No. : 04 -2007

**Subject : EXU 16 – 0140, EXU 18 – 0141, EXU 20 - 0142
„BOOMERANG - Side Protection “**

We have received several complaints about damaged or torn off motor covers on EXU – trucks and we have decided to set up in series a metallic protection.

Original version **without**
„Boomerang“

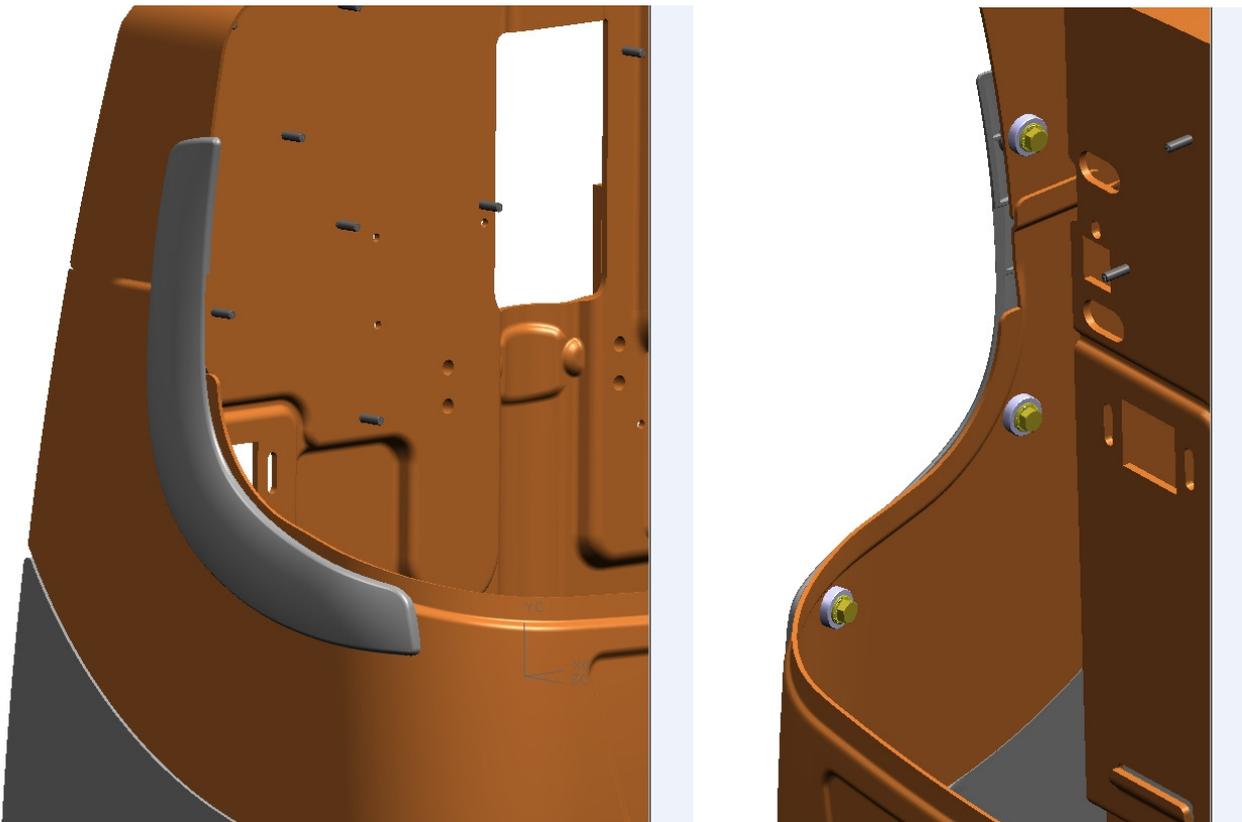
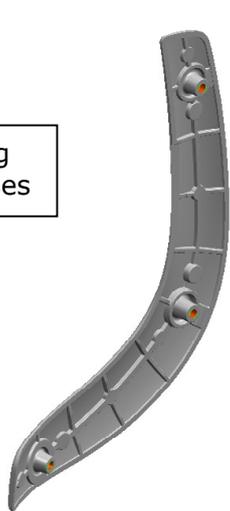
The interest of this side protection is to prevent the motor cover from being damaged or torn off when loading or unloading different products.

The Boomerang has a slightly curved shape which adapts with precision to the chassis :

Inside Boomerang
with 3 fixing bosses

Outside Boomerang
slightly curved

Mounting of the two Boomerangs in After-Sales Service :

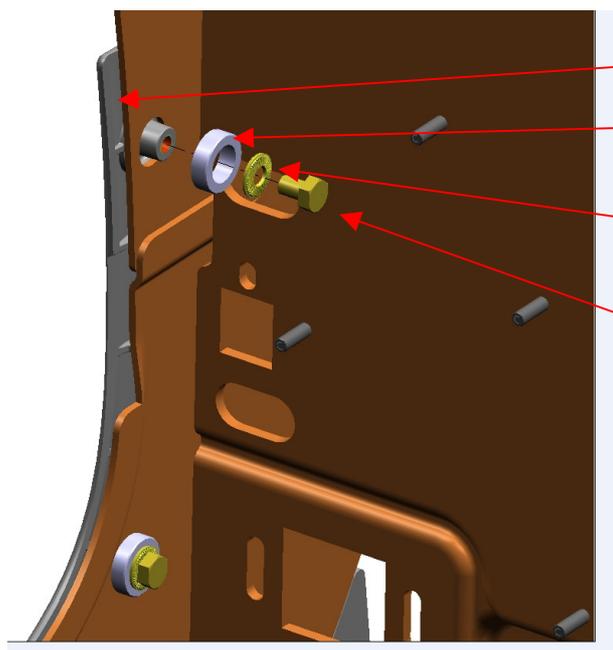
Bore 3 holes and add the parts ordered (see below) :

- A) Boomerang**
- B) Big washer**
- C) Thin washer**
- D) Screw**

In the following I joint the mounting plan :

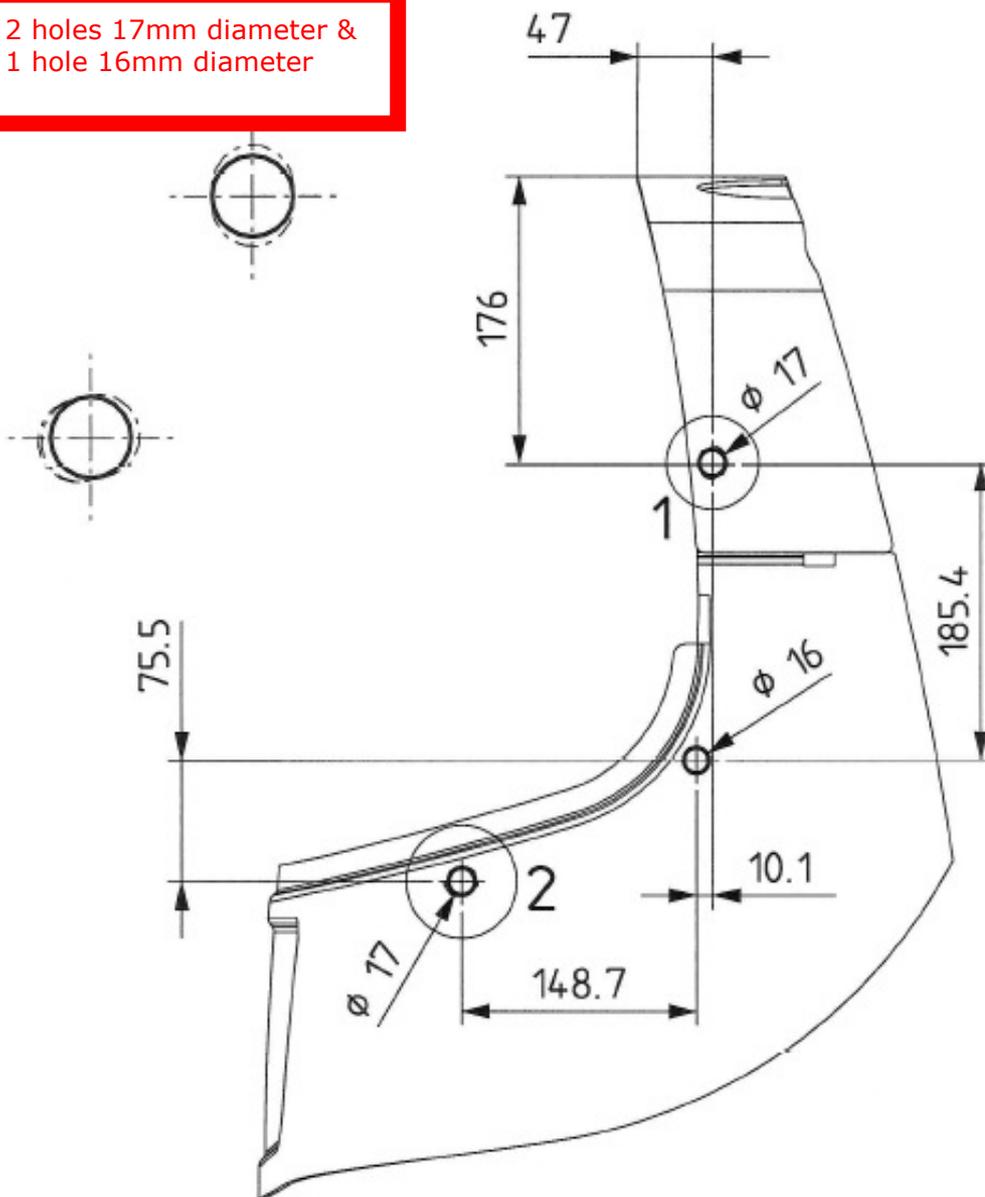
2 holes 17mm diameter &
1 hole 16mm diameter
